## Api 521 Heat Exchanger Tube Rupture Case

Started by smuk, Jan 12 2020 10:04 PM

The purpose of presenting this analysis of a tube rupture scenario of the Steam Heater (refer the attached sketch) is to obtain a confirmation of the correctness of the analysis form domain experts in the group.

Fig. 1 of "Assure delayed coker safety" (March 1992, p. 109) needs to be clarified and corrected.

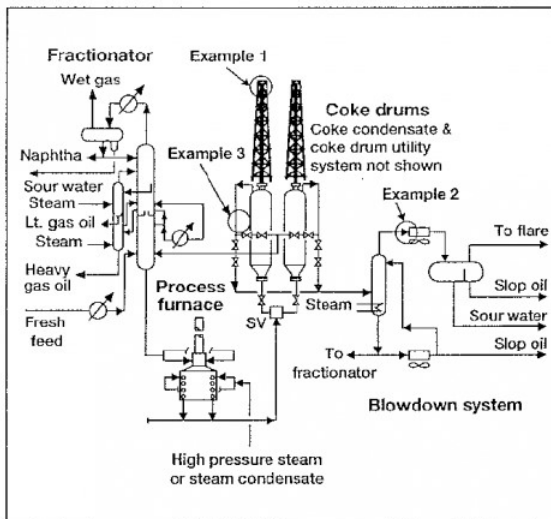
1. The identification of Examples 1 and 3 should be indicated. As printed, all "Examples" were shown as "Example 2."

2. For clarity and correction, add or change various flow directions.

3. The fractionator should be indicated with a total draw pan at the heavy gas oil product draw.

4. Releases from the blowdown system that are labeled "Slop oil" should be correctly labeled "Slop oil."
